Amendments to the Drawings:

Title: HIGH PRESSURE DISCHARGE LAMP ARC TUBE AND METHOD OF PRODUCING THE SAME
Our Docket No.: 939_026
REPLACEMENT SHEET

FIG. 6 - PRIOR ART

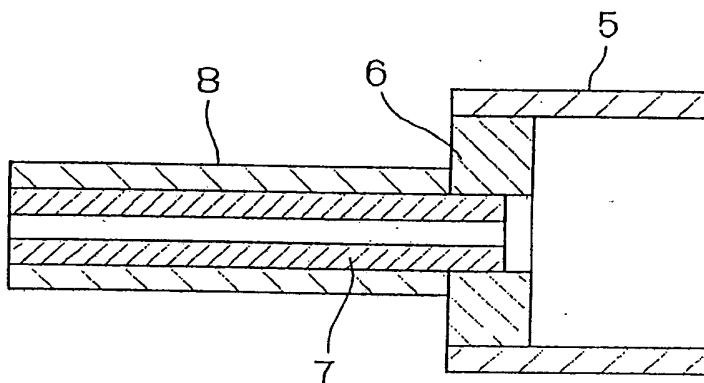
The attached sheet of drawings includes changes to Fig. 6. This replacement sheet, which includes Figs. 5 and 6, replaces the original sheet including Figs. 5 and 6. In Fig. 6, the legend --PRIOR ART-- has been added. No changes have been made to Fig. 5. Applicants respectfully submit that no new matter has been added.
